Star Pointe Plaza Consent Amendment: Site Plan 82010002A

Staff Report Date: 11/07/14

Star Pointe Plaza Consent Amendment: Site Plan 82010002A: Request to reduce the total lot area, green area and side yard building and parking setbacks as a result of a boundary dispute, located on the south side of Sandy Spring Road (MD 198), approximately 100 feet west of Star Pointe Lane, 1.53 acres, I-1 Zone, Burtonsville Employment Area Overlay Zone; Fairland Master Plan.

Attachment A – Red line Site Plan

SITE PLAN
DATE: 06/25/2010
SCALE: 1" = 30'
SHEET: C-2
CHECKED: 3 OF 9

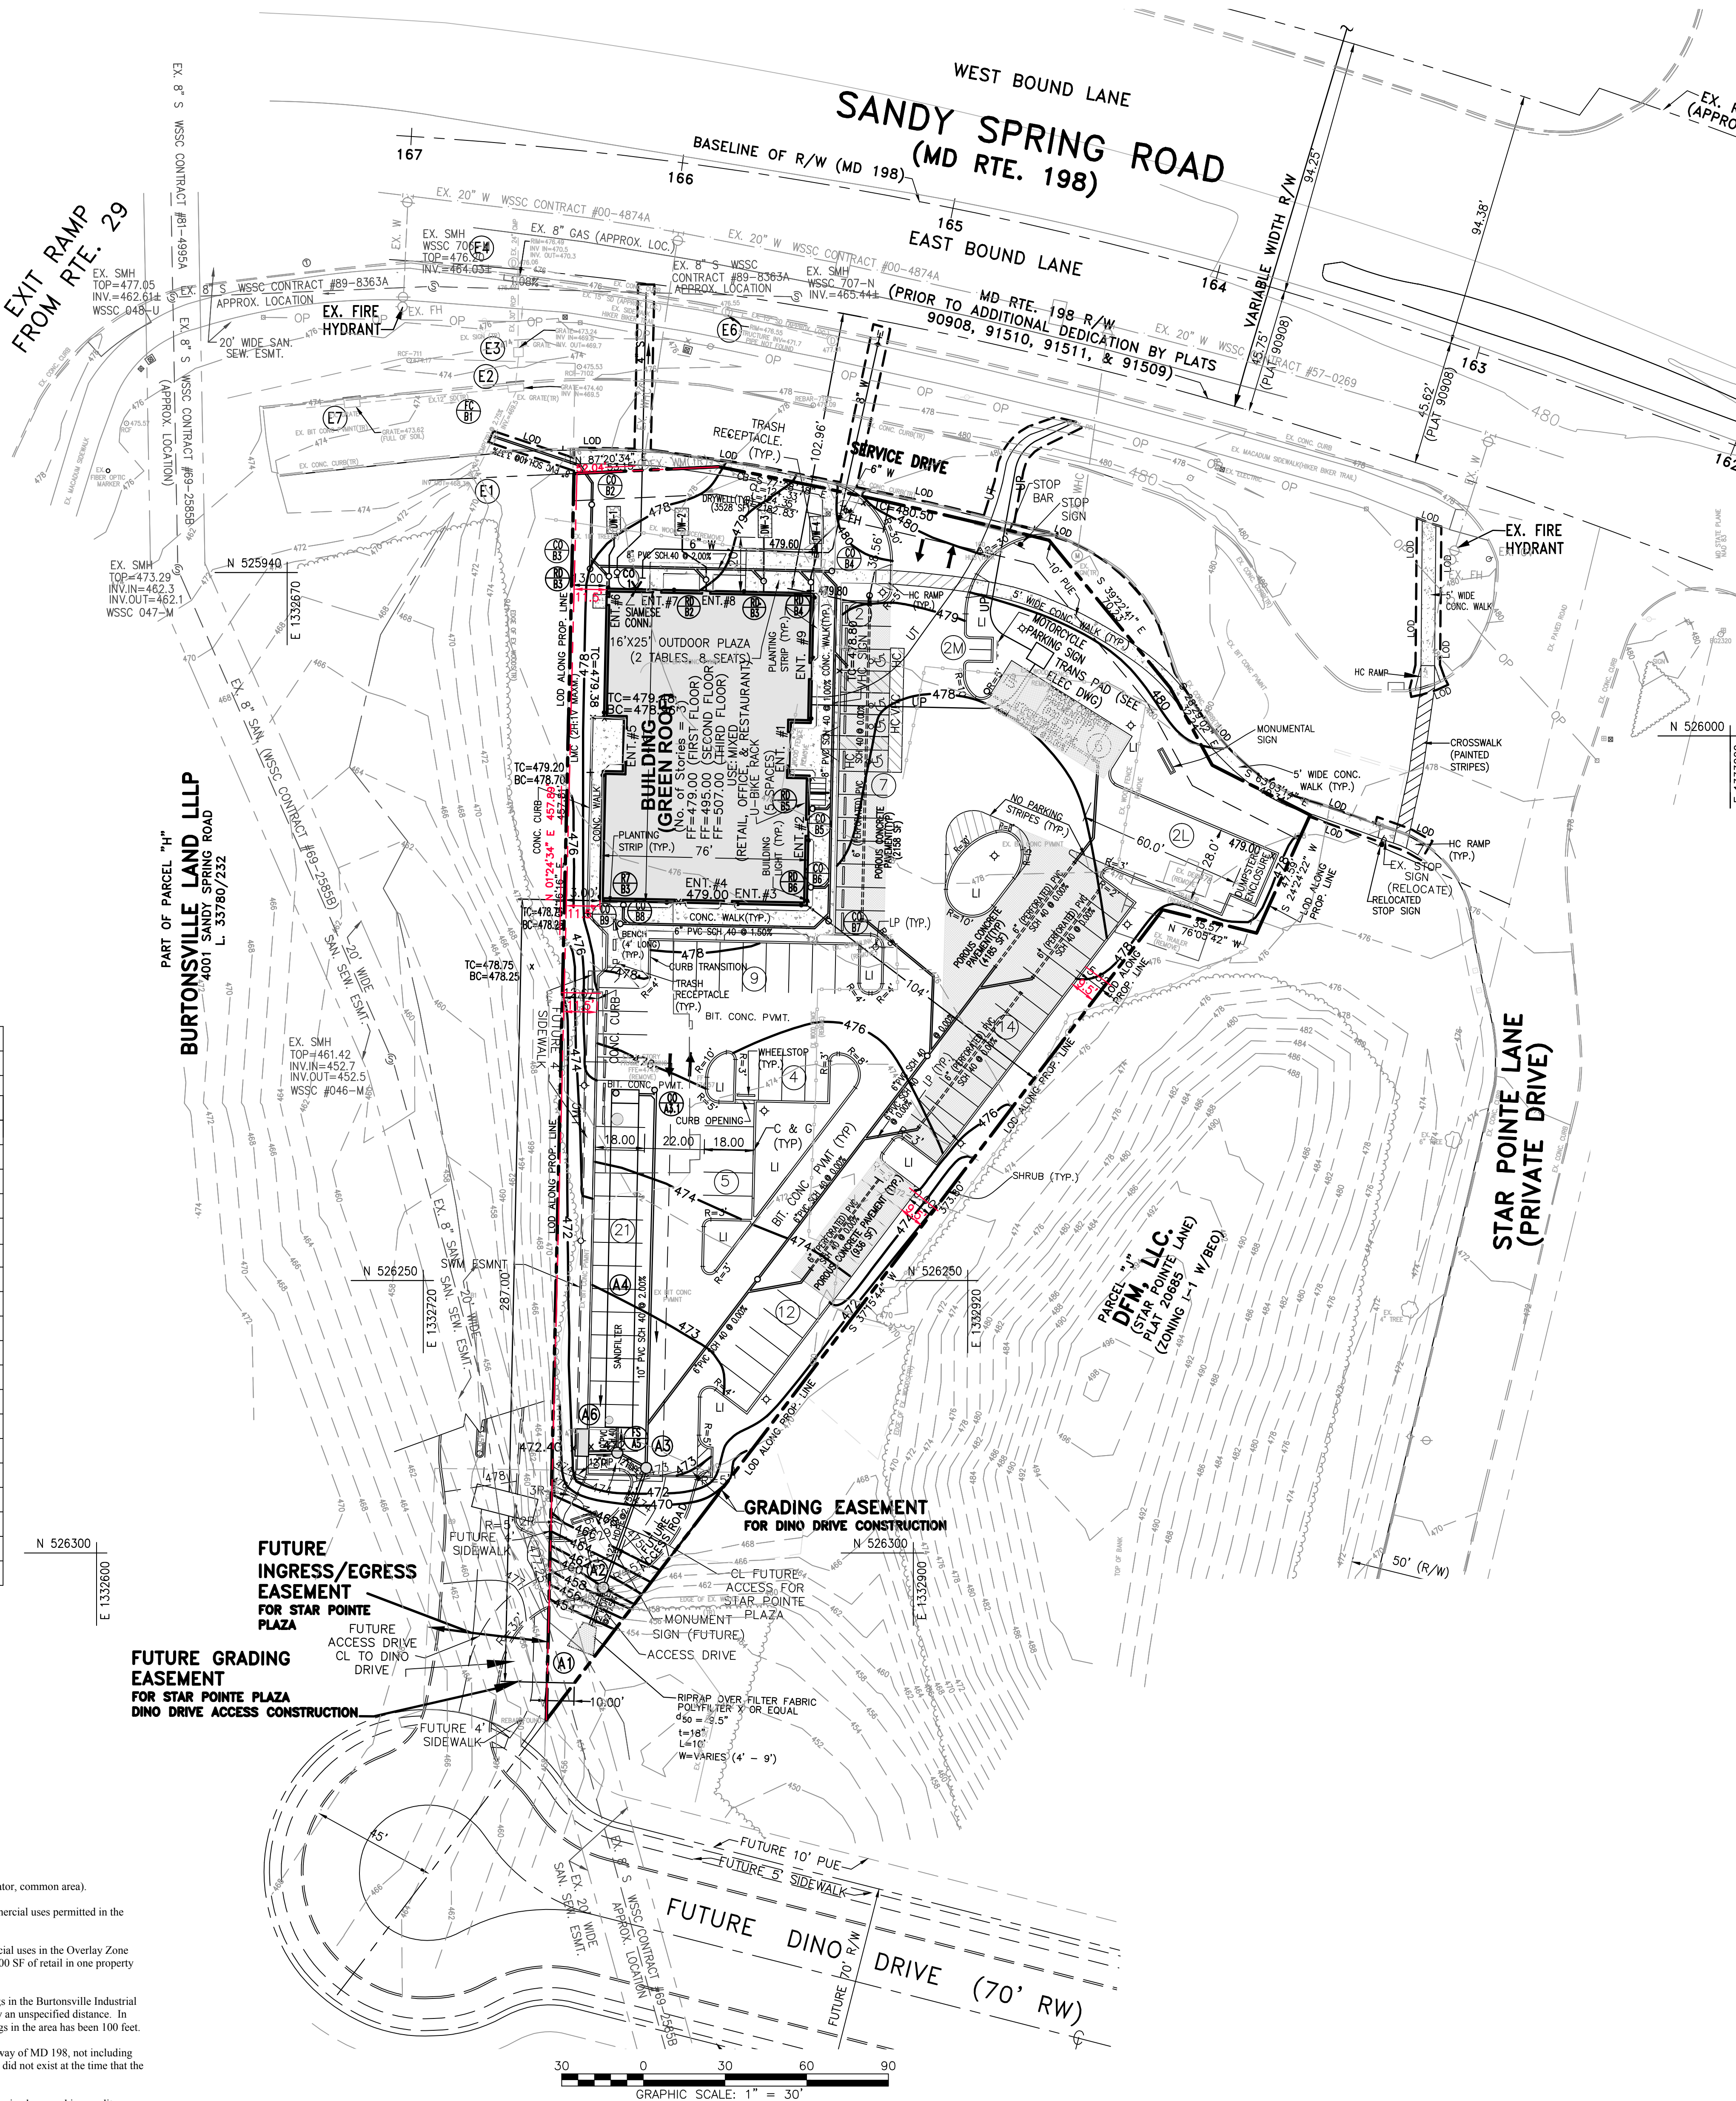
- a) Reduction in total lot area from 67,058 sq. ft. (1.54 acres) to 66,805 sq. ft. (1.53 acres);
- b) Increase in total FAR from 0.37 FAR to 0.38 FAR;
- c) Reduction in side yard setbacks on the western side from 13 feet to 11.5 feet and the eastern property line from 10 feet to 9.5 feet;
- d) Reduction in Green area from 31,447 sq. ft. (46.9%) to 24,400 sq. ft. (36.5%).

The requested amendment will not have an impact on Site Plan findings; but the dimensions on the plan drawing and the project data table for the I-1 Zone need to be adjusted with the new figures as shown in Table 1.

The reduced lot area meets the minimum size allowed in the zone, and the FAR is acceptable because there is no explicit FAR limit in the I-1 Zone. The zone has no required side yard setbacks when abutting other industrial or commercial zoned land, however the previous Site Plan placed a 13 foot setback for the western side yard and a 10 foot setback for the parking along the eastern boundary. MCDPS has found that the wall of the building is actually 12 feet from the western Subject Property boundary and the parking is 9.5 feet from the eastern boundary. The Applicant's request of 11.5 feet is to provide a little extra room for façade treatments or other surveying errors.

The minimum green area for the I-1 Zone is 10 percent. The green area provided in this Application is 24,400 sq. ft (36.5 percent). The area provided as green area is geometrically the same as that shown on the certified Site Plan No. 820100020, however the area provided in the data table at that time was

incorrect, and the acreage of the total lot has been reduced slightly. This Application amends the table to show the accurate area of green space provided.

Development Standard	Permitted/Required	Proposed for Approval & Binding on the Applicant
Gross Tract Area (GTA) (square feet/acre)	n/a	62,058-64- (41.54 acres) 66,805 SF (41.53 acres)
Net Lot Area (square feet/acre)	n/a	62,058-64- (41.54 acres) 66,805 SF (41.53 acres)
Gross Floor Area (GFA) & FAR		
-Retail restaurant	n/a	8,431 SF ^(a) (0.126 FAR)
-General office	n/a	2,16,808 SF + 49,244 FAR
Total	n/a	25,239 SF (0.252 FAR)
Max. Cumulative retail/commercial uses in Overlay Zone (SF)	50,000 SF ^(b)	24,031 (c)
Max. Building Height (feet) 59-C-5.3		
-In stories	3	3
-In feet	42	42
Min. Building Setbacks (feet)		
-Major highway	100 ^(d)	100 ^(e)
-Other property lines (Sec. 59-C-18.142(b)(1))	0	
-West		42- 11.5
-South		287
-East		104
Min. Parking Setbacks (feet)		
-Major highway	100	100
-Other property lines (Sec. 59-C-18.142(b)(1))	0	
-West	0	42- 11.5
-East	0	42- 9.50
Parking Lot Internal Landscape % of surface pkg facility	5 (1,740 SF)	6.8 (2,357 SF)

Min. Green Area (% of GTA) 59-C-5.3	10	46- 36.5
	46-706 SF (6.681 SF)	421,472 SF (24,400 SF)
Total Parking Spaces	116 (84) ^(f)	(84) ^(f)
-Office (16,808 SF)	48.7 (@ 2.9 sp/1000 SF)	
-Retail (3,100 SF)	15.5 (@ 5 sp/1000 SF)	
-Restaurant, patron internal (1,927 SF)	48.2 (@ 25 sp/1000 SF)	
-Restaurant, patron external (210 SF)	3.2 (@ 15 sp/1000 SF)	
-Restaurant, non-patron area (1,333 SF)	0 (@ 0 sp/1000 SF)	
Handicap Spaces	4	4
Bicycle spaces (59-E-2.3(a))	5	5
(@ 1 bike space/20 vehicle spaces)	84 vehicle sp/20	
Motorcycle spaces (59-E-2.3(d))	2	2
(@ 2% x total vehicle spaces)	(2% x 84 vehicle sp)
